Brunswick[®]
SERVICE

Subject: Wick Pad Update Notification

Bulletin No. CEB02-7

Figure 1 - Initial Style (153-8103)

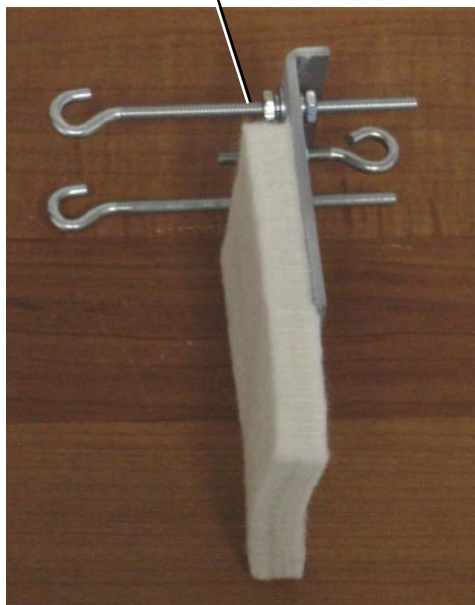
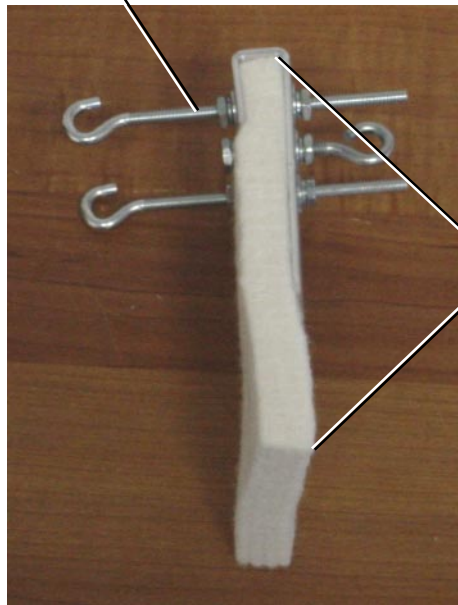
The purpose of this bulletin is to inform all Pad machine operators of a design change that has been made to the support plate of the wick pad assemblies. The new design eliminates the use of adhesive to attach the wick material to the wick plate, making them “glueless”. The new support plate is shaped like a “J” and holds the wick material using the hardware that is supplied with the assembly. The wick material for the new assemblies is now one inch taller totaling five inches (point of contact with transfer roller remains the same). This change makes replacing the wick material much easier. All wick sizes are affected but will not be available until existing stock is depleted from inventory. Refer to Figures 1 and 2 for photos that will point out the specific changes that have been made.

EYEBOLTS ARE ABOVE
WICK MATERIAL.
WICK FELT IS
GLUED TO PLATE.

EYEBOLTS PASS
THROUGH
WICK MATERIAL,
SECURING IT TO
THE PLATE

WICK MATERIAL IS
1 INCH TALLER TO
COMPENSATE FOR IT
BEING RECESSED
INTO PLATE. OVERALL
ASSEMBLY IS STILL
SAME SIZE AS
INITIAL STYLE.

Figure 2 - Improved Style (153-8103A)
